Delegated Report		Analysis sheet		Expiry Date:	23/03/2021
		N/A		Consultation Expiry Date:	01/03/2021
Officer				Application Number(s)	
Charlotte Meynell				2021/0356/HS2	
Application Address				Drawing Numbers	
Granby Terrace and Land within Railway Cutting to South London NW1 3SA				Please refer to decision notice	
PO 3/4	Area Team Signature	C&UD	Authorised Officer Signature		
Proposals					
Application for approval under Schedule 17 of High Speed Rail (London - West Midlands) Act 2017 of a two-span expansion to the existing Granby Terrace Bridge (in the Euston Approaches) to provide a connection over the new HS2 rail corridor comprising of a bridge structure and parapets; and the installation of supporting concrete props for the provision of bridge support and ground stability.					
Recommendations:		Grant Consent			
Application Type:		Schedule 17 – Conditions of Deemed Planning Permission			
Conditions or Reasons for Refusal:		Refer to Decision Notice

- A two-span concrete frame bridge structure with a width of 15m and depth of 58m, to form an extension to the existing Granby Terrace Bridge to the junction with Stanhope Street and Park Village East, to support the Granby Terra

Figure 1: The proposed works for approval

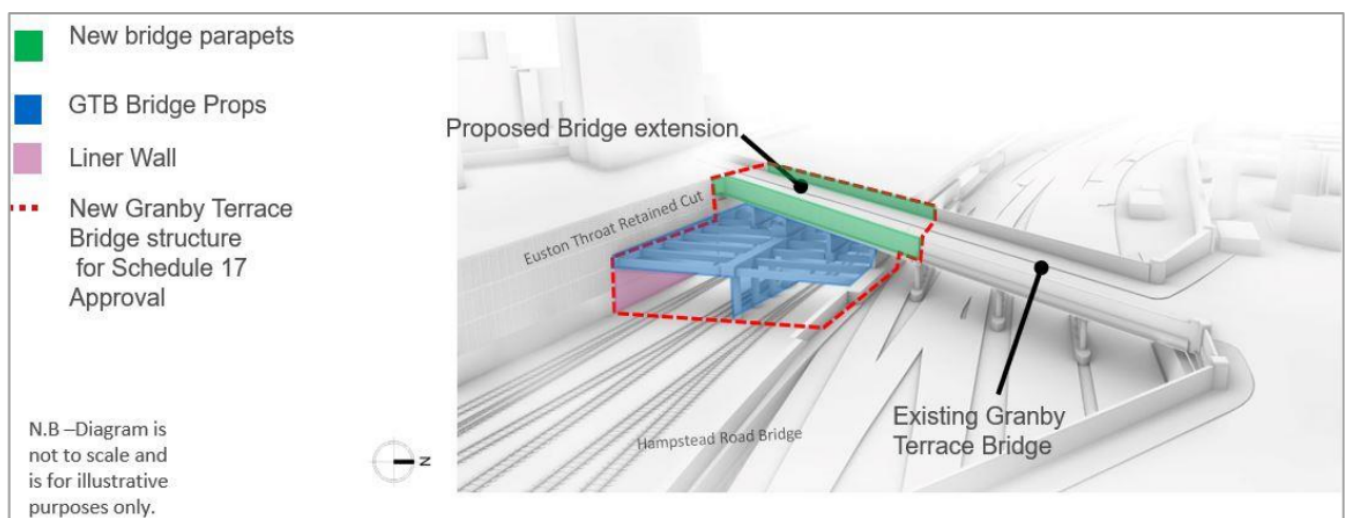
- 3.4 The proposed works are defined as building works and earthworks in accordance with Schedule 17 of the Act. The applicant identifies within their submission that some of the building works (lower sections of central support concrete columns and supporting base slab with internal piles underneath) are below ground level. These below ground elements do not require approval by the Local Planning Authority by virtue of paragraph 30(g), Schedule 17 of the Act and are therefore not part of this assessment. Furthermore, the proposed works interface with the approved Euston Throat Retained Cut (ETRC) retaining walls to the east and west, and the ETRC parapet walls to the west. Therefore, officers are only considering the above ground sections of the support props, the proposed bridge structure, the parapet walls, and the retaining and liner walls situated beneath the ETRC retaining walls.

Figure 2: Rendered view of transition between the existing (to the right) and proposed (to the left) Granby Terrace Bridge parapet walls, looking north-east

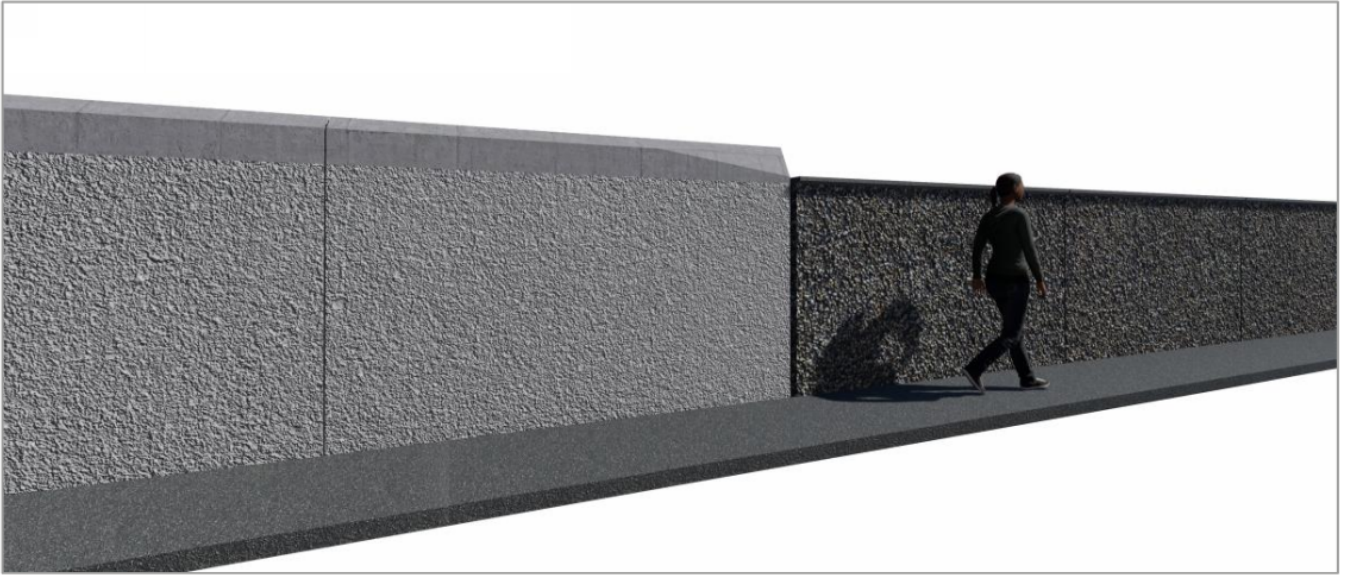
- 3.7 The existing bridge parapet walls are 1.65m high, but the proposed bridge extension requires parapet walls with a height of 1.8m to meet current safety standards. The profile to the top of the proposed parapet walls would also be different to the existing parapets, for the safety of the wall as a barrier and to discourage climbing. The proposed 'shadow gap' is considered to provide the most effective and 'honest' solution rather than, for example, splicing the two structures together in an attempt to disguise the transition. The addition of a splay to the triangular 'steeple' top of the proposed parapet walls adjacent to the existing flat-topped parapets aids the transition between the differing geometries of the parapet walls. A condition will be added to secure the submission of further detailed drawings of the transition between the existing and proposed parapet walls, including the shadow gap and splay to the proposed coping, to both sides of the bridge, to ensure a successful transition.

- 3.8 In terms of providing a degree of continuity between the existing flint finish to the pavement facing parapet wall, an exposed aggregate finish is proposed as the preferred option. This option is considered to provide a continuity of character of the wall surface whilst differentiating

itself as a new addition. It also provides a deterrent to graffiti. The precise finish of the exposed aggregate will be the subject of an approval of details application to secure the appropriate particle size and colour and therefore a condition is recommended to be added to any permission.
